**GENERAL**

This addendum forms a part of the Contract Documents and modifies the original Bidding Documents dated JUNE 2023, and consists of pages AD1-1 through AD1-2, various Contract Documents, Specifications Table of Contents, Specification Section 028213.19 Drawings Sheets (A0.01, I1.00, I2.06), and Hazmat report dated 06/19/2023. The following changes, additions and/or deletions shall be made to the following documents; all other conditions shall remain the same.

**FOR: PROJECT NO. M057295  
SHER BLDG PHARM  
RELOCATE PHARM STAFF FROM N-S WINGS  
UNIVERSITY OF CALIFORNIA  
UC DAVIS HEALTH  
SACRAMENTO, CALIFORNIA**

Account No.: M057295  
Arch/Engr: KY  
UDCMC Project Mgr: KM  
Scale: 12" = 1'-0"  
SHEET NO. **A0.01**

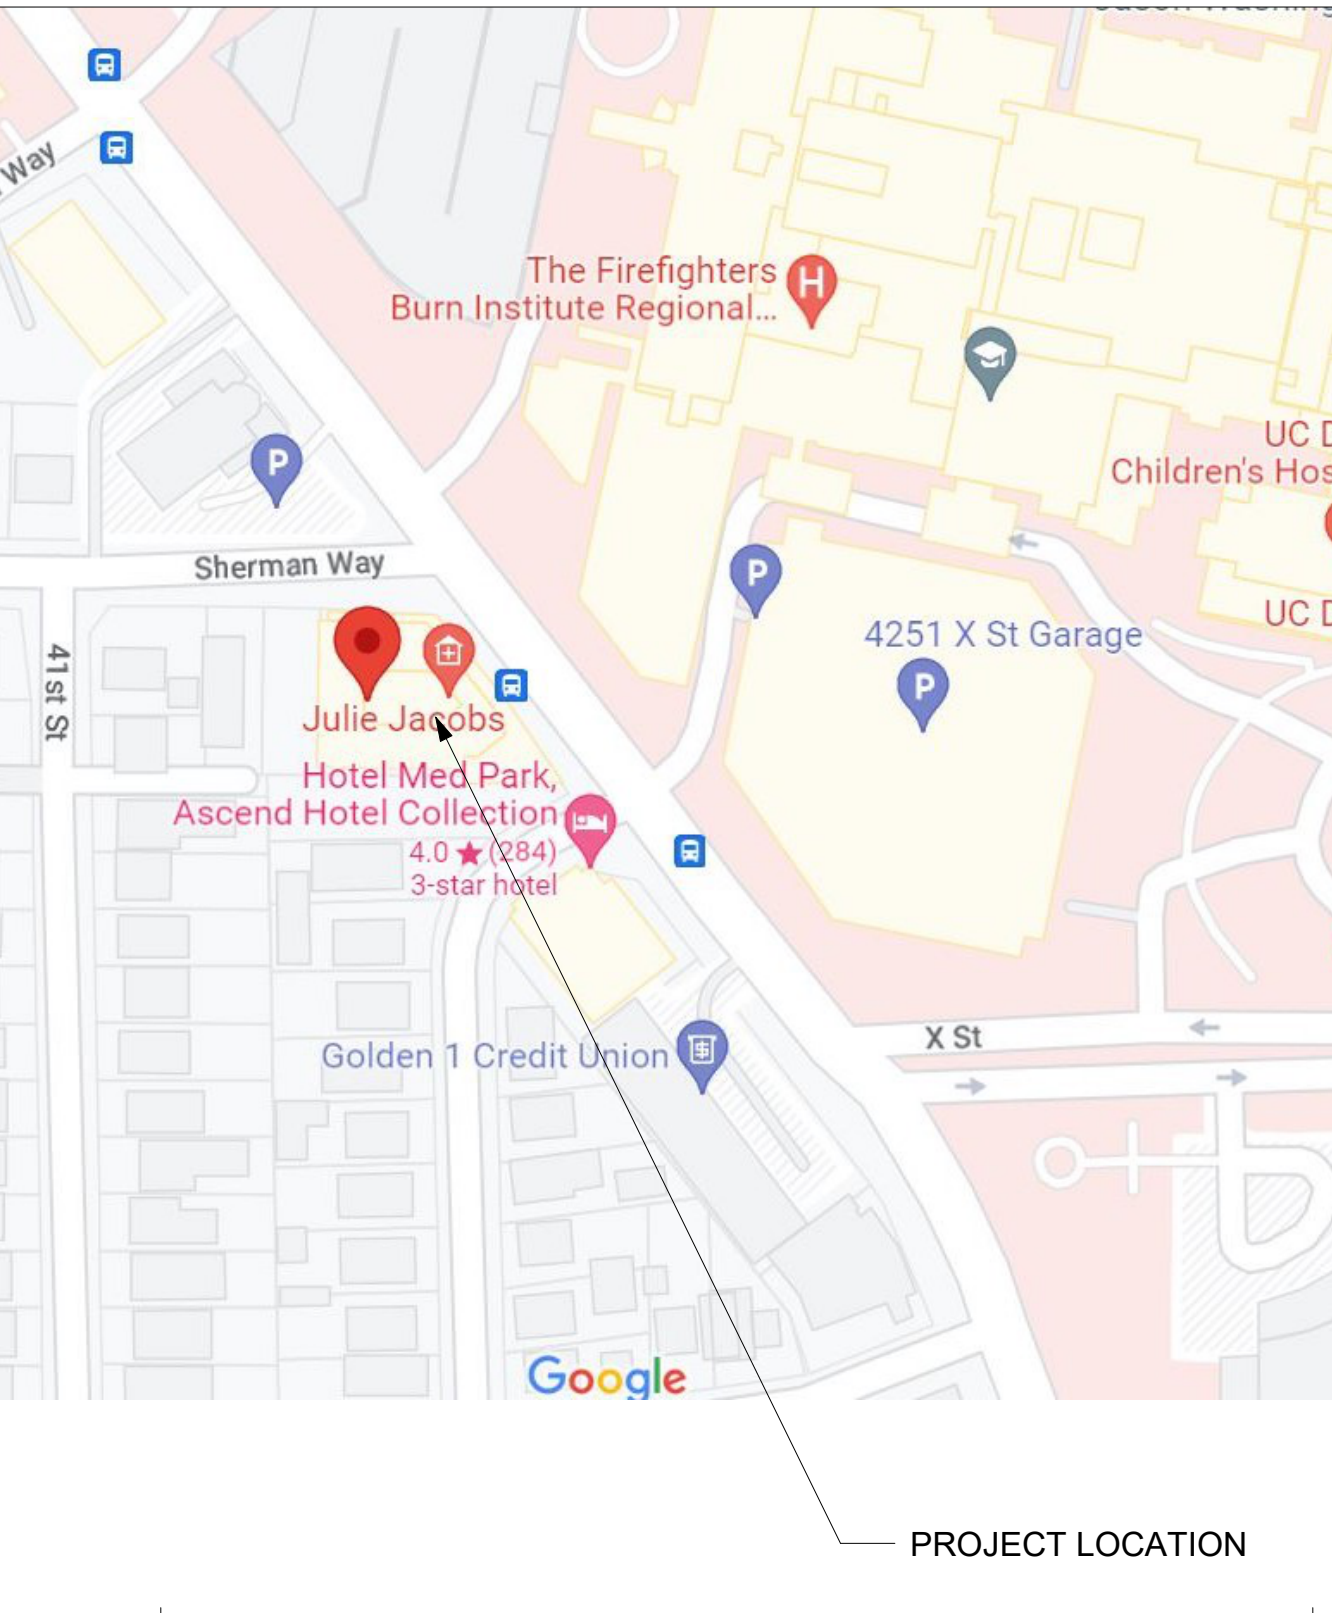
1. A0.01 – TITLE SHEET
  - REPLACE A0.01 in entirety with the attached.
  - ADDED the following statement to Scope of Work:
    - “All existing window shades to be protected during construction.”
  - ADDED the following sheet to Index of Drawings:
    - I2.05 - Flooring Distribution Plan - Third Floor

GENERAL SCOPE OF WORK CONSISTS OF:  
REMOVE AND REPLACE EXISTING FLOORING AND BASE WITH NEW FINISHES PER DRAWINGS AND SPECIFICATIONS. 1<sup>ST</sup> FLOOR AND 2<sup>ND</sup> FLOOR. 3<sup>RD</sup> FLOOR, EXISTING FLOORING TO REMAIN WITH SOME REPLACEMENT OF EXISTING STAINED CARPET TILES. ALL EXISTING WINDOW SHADES TO BE PROTECTED DURING CONSTRUCTION.

Account No.: M057295  
 HCA No.: N/A  
 Blig. No.:  
 SHERMAN WAY BUILDING #056  
 FIRST, SECOND & THIRD FLOOR  
 Project: M057295 - SHER BLDG PHARM RELOCATE PHARM STAFF FROM N-S WINGS  
 Sheet Title: FLOORING DISTRIBUTION PLAN - THIRD FLOOR

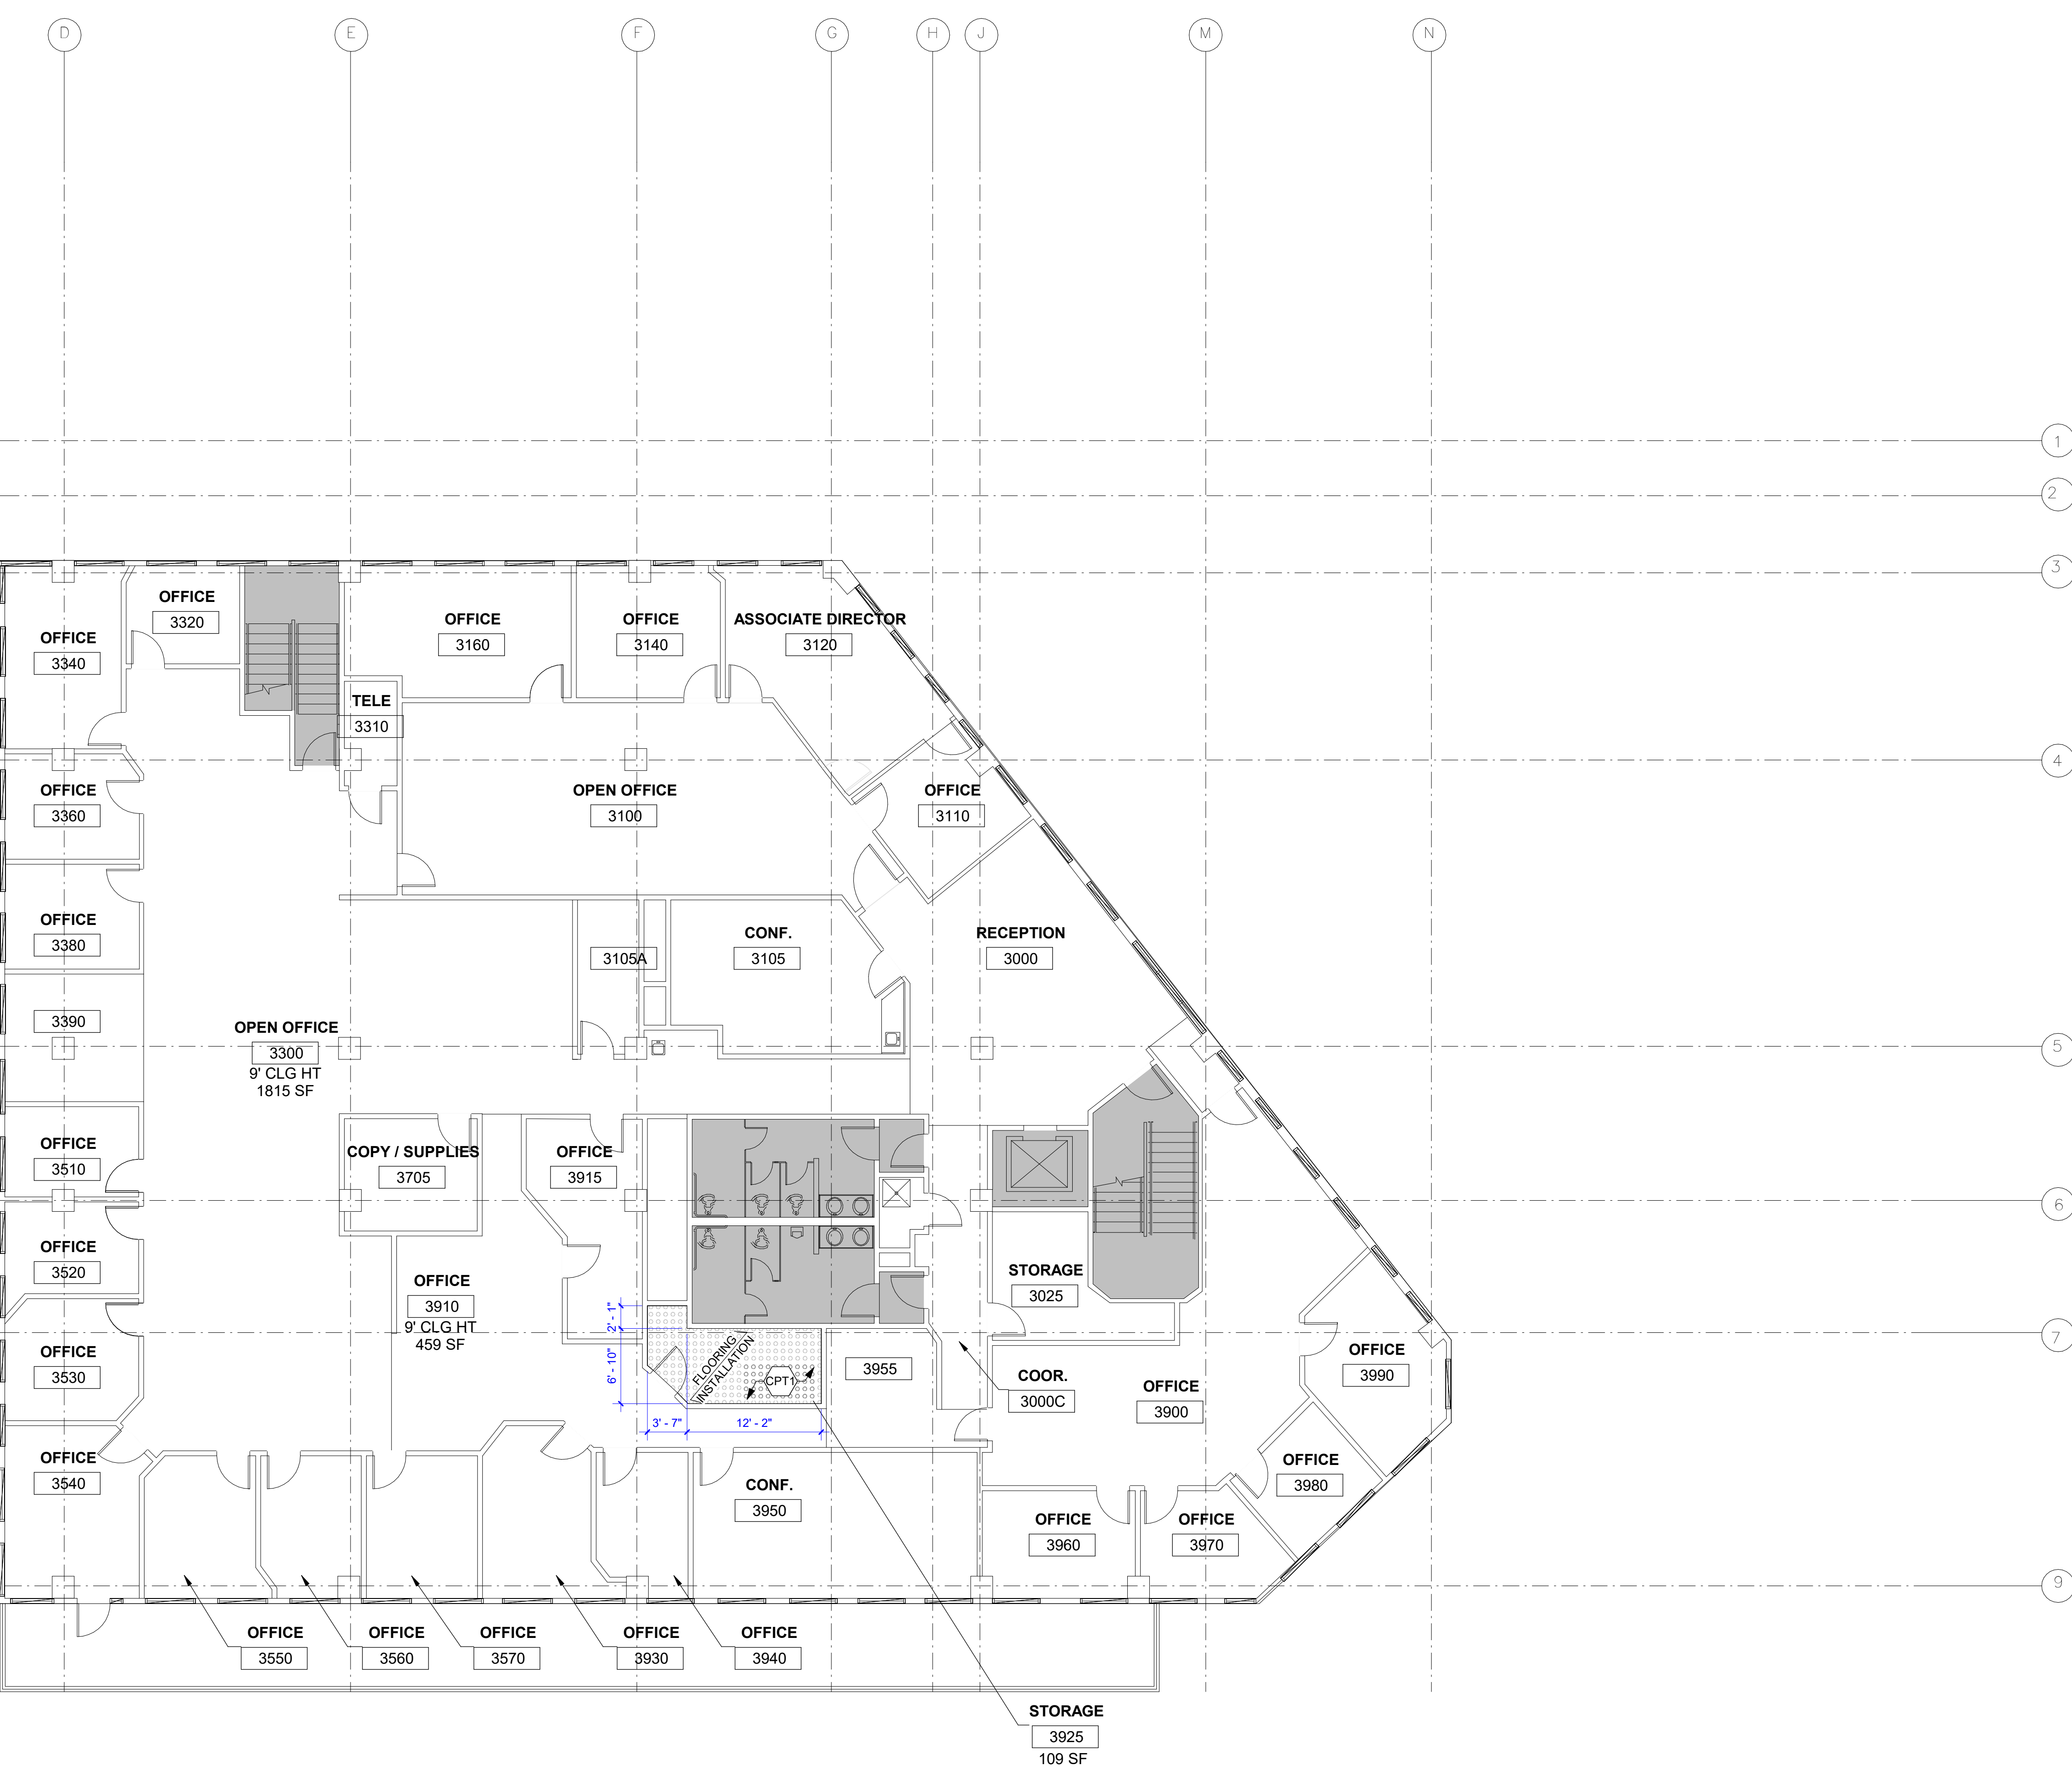
3. I2.06 – FLOORING DISTRIBUTION PLAN – THIRD FLOOR
- ADDED sheet to Set.
